Duke Street – Anne Street South  
Public Realm Scheme

Stage 1 Road Safety Audit

**Document Ref:** P22-184-RSA-PD-RP-001

*Location:* Drawing Nos. CA17010 PLAN-P 20 (Rev. A) & CA17010PLAN-P 30 (Rev. A)

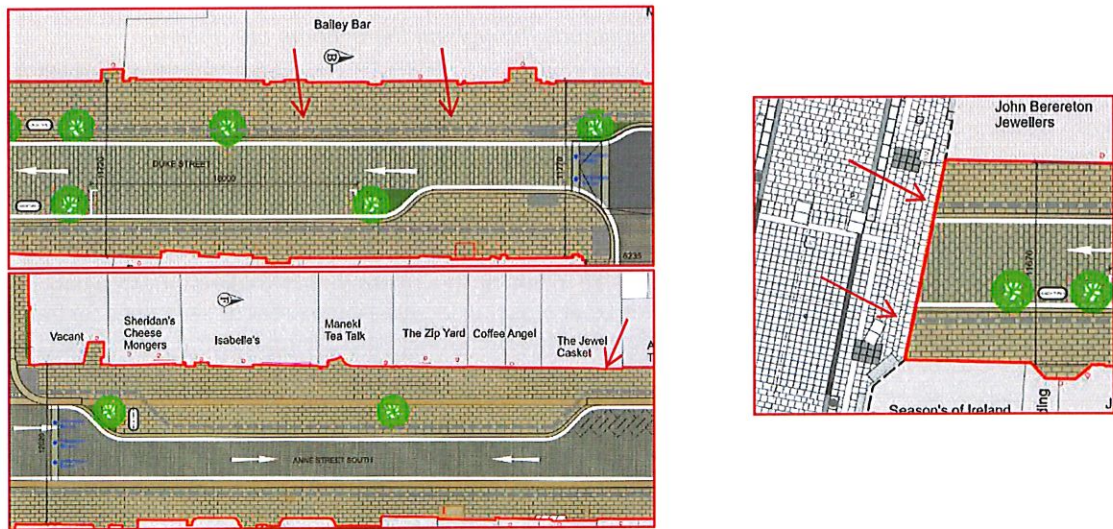
*Summary:* The “Tactile Indicator” paving layout shown within the drawings may not be sufficiently detectible to visually-impaired pedestrians and may lead them towards obstacles within the footpath.

The cross-sections provided indicate that the footpath would be flush with the adjacent carriageway on Duke Street (West) and Anne Street South (East & West). It is proposed to create a “Safe Zone” for visually-impaired pedestrians through the provision of “tactile indicator” paving.

At these locations, both the footpath and the adjacent carriageway would consist of granite flags or setts. It is unclear if there would be sufficient tonal contrast between the footpath areas and the shared carriageway area, and between the footpath/carriageway and the tactile indicators. It is also unclear what the width and profile of the proposed tactile indicators is to be. Should the tactile indicators be insufficiently detectible, this may create difficulties for partially-sighted and visually-impaired pedestrians identifying the Safe Zone within the street, increasing the difficulties experienced by these road users in independently & safely navigating the proposed street layout.

The tactile indicator layout on the northern side of Anne Street South (east) and Duke Street (west) is indicated as following the kerb line where the footpath widens to provide a buildout area. However, within the Safe Zone created by the tactile indicator there are a number of items of street furniture which could present a hazard to the visually impaired. In some locations the tactile indicator is shown to be in line with the centre of the proposed tree planting which could direct visually-impaired pedestrians into the obstruction.

In addition, the tactile indicator proposed along Anne Street South and Duke Street is not shown extending to meet the existing tactile indicator on Grafton Street. The lack of continuity of measures to assist the visually-impaired could increase the difficulty experienced by these road users in navigating the proposed street layout.

Tactile indicators should be provided in accordance with the Traffic Management Guidelines, which refers to the “Guidance on the Use of Tactile Paving Surfaces” published by UK Department for Transport (Ref. Chapter 6).

The proposed tactile indicator on Duke Street and Anne Street South should be extended to provide a connection into existing tactile delineators along Grafton Street.

Location: Drawing No. CA17010 PLAN-P 20 (Rev. A)

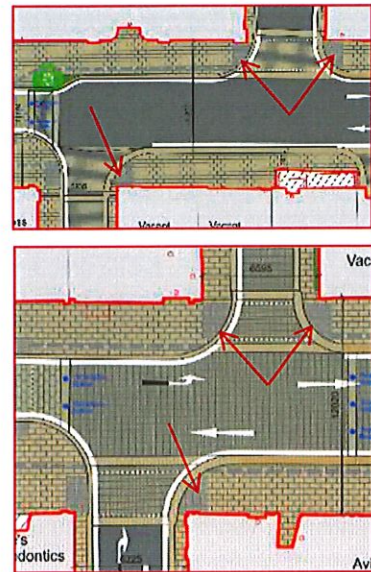
Summary: An insufficient depth of tactile paving has been indicated at various uncontrolled pedestrian crossings throughout the scheme.

At the uncontrolled crossings along Duke Street at its junctions with Dawson Street, Duke Lane and Anne Street South, as well as at the uncontrolled crossing of Anne's Lane, the depth of the tactile paving does not appear to be sufficient for an in-line approach to the crossing.

Should the tactile paving provided at these locations be of an insufficient depth this could lead to visually-impaired pedestrians stepping over the tactile paving layout and inadvertently entering the carriageway where there is an increased risk of being struck by a vehicle.

The tactile paving provided at in-line uncontrolled crossings should be a minimum of 1.2m (three rows) deep across the full width of the dropped kerb.

Location: Drawing No. CA17010 PLAN-P 20 (Rev. A)

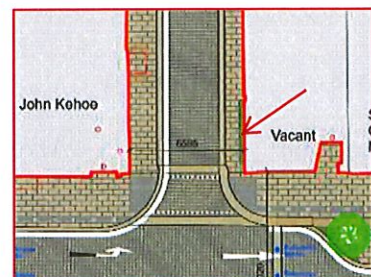
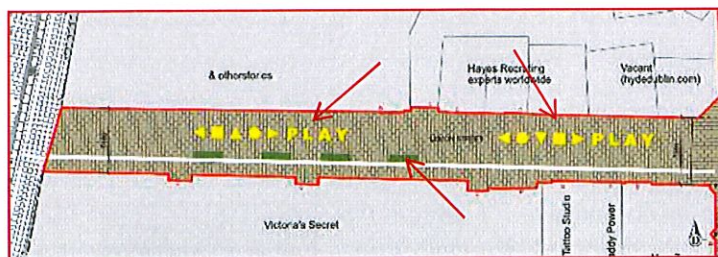
Summary: Proposed "Play Installations" and "In-ground Planting" areas on Lemon Street and Duke Lane Upper may present a hazard to pedestrians and reduce the effective width of the footpath.

Two "Play" areas/installations are proposed on Lemon Street along with some "in-ground planting areas". At this early stage in the design development it is unclear what items of furniture, and their layout, are proposed on Lemon Street. If inappropriate roadside furniture items are proposed, or if there placed in an inappropriate location, they could present a hazard to inattentive pedestrians or to the visually-impaired/partially-sighted. Should the installations and in-ground planting areas result in the effective width being too narrow, they could create an obstacle to the mobility impaired, in particular wheelchair users.

In addition, an "In-ground Planting" area is indicated on the east side of Duke Lane Upper at the junction with Anne Street South. This could reduce the effective width of the footpath creating difficulties for the mobility impaired, in particular wheelchair users, travelling within the footpath.

During the Detailed Design phase, ensure that the proposed landscaping and "Play Installations" do not create hazards for non-motorised road users or obstacles for the mobility-impaired.

*Location: Drawing No. CA17010 PLAN-P 20 (Rev. A)*

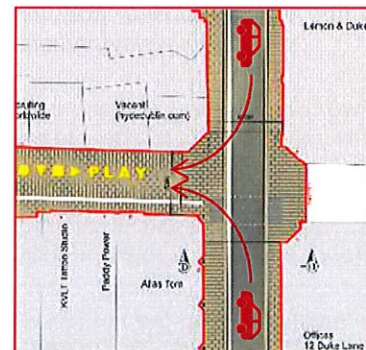
*Summary: The operation of the retractable bollards is unclear.*

A number of retractable bollards have been indicated at Duke Street and Anne Street South, it is assumed that these bollards will be raised outside of delivery hours. There is a risk that road users may be insufficiently aware of the dynamic bollards as they transition from being inactive (i.e. down) to active (i.e. raised).

Should road users be insufficiently aware of the activation (rising/lowering) of the bollards, they may fail to react to, and avoid, the bollards in time. This could result in material damage or personal injury collisions.

The proposed retractable bollards should include audible and visual signals to alert all road users of their transitioning operation and should be designed to remain inactive if an approaching vehicle is detected or a stationary vehicle is detected overhead.

*Location: Drawing No. CA17010 PLAN-P 20 (Rev. A)*

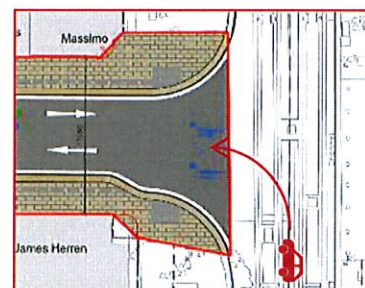
*Summary: Drivers may be insufficiently aware that there is no vehicular access to Lemon Street.*

It is assumed that no vehicular access is intended to Lemon Street. However, as the pavement of the Lemon Street and the adjacent Duke Lane Upper carriageway appear to be at the same level, drivers may fail to understand this and attempt to drive onto Lemon Street, with resulting increased risk of vehicular/pedestrian collisions.

Where a driver has inadvertently commenced turning onto Lemon Street, they may then attempt reversing back into Duke Lane Upper with a resulting increased risk of result in a vehicle-pedestrian collision.

During the Detailed Design measures should be provided to clearly advise drivers on Duke Lane that vehicles should not enter Lemon Street.

*Location: Drawing No. CA17010 PLAN-P 20 (Rev. A)*

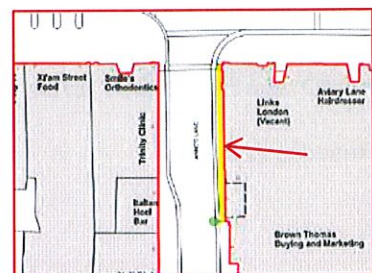
*Summary: A relatively wide gap has been indicated between the proposed retractable bollards on Anne Street South at the junction with Dawson Street, which may result in vehicles entering outside of the permitted hours.*

Two retractable bollards are indicated on Anne Street South at the junction with Dawson Street and there appears to be a gap approximately 2.75m wide between them. A space of this width would allow a vehicle to pass and may insufficiently deter all drivers from entering, or attempting to enter, Anne Street South outside of the permitted delivery hours while the bollards are raised.

Should a vehicle enter Anne Street South while the retractable bollards are raised, there is a risk that they may strike a pedestrian travelling within the carriageway. Additionally, the vehicle may become trapped due to the closely spaced proposed retractable bollards located westwards on Anne Street South.

The spacing of the proposed retractable bollards within the scheme should be such that vehicles are unable to pass between the bollards when raised.

*Location:* Drawing No. CA17010 PLAN-P 29 (Rev. A)

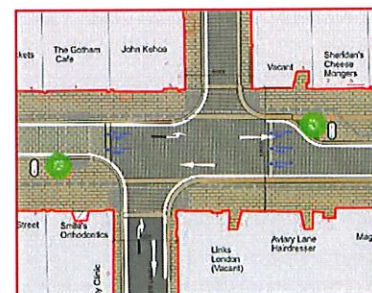
*Summary:* It is unclear where the proposed "Vertical Feature Lighting" installations will be mounted.

Two areas of "Vertical Feature Lighting Installations" are indicated on Duke Lane Upper and Anne's Lane. It is unclear from the information provided whether the proposed "Vertical Feature Lighting" installations will be mounted on the pavement or on building façades.

If mounted on the pavement, they may reduce the effective width of the footpaths within which they are mounted, presenting a potential obstacle to the mobility impaired, in particular wheelchair users, or lead to pedestrians stepping into the adjacent carriageway where they are at risk of being stuck by a vehicle.

During the Detailed Design the proposed "Vertical Feature Lighting Installations" should be designed such that they do not reduce the effective width of the footpaths.
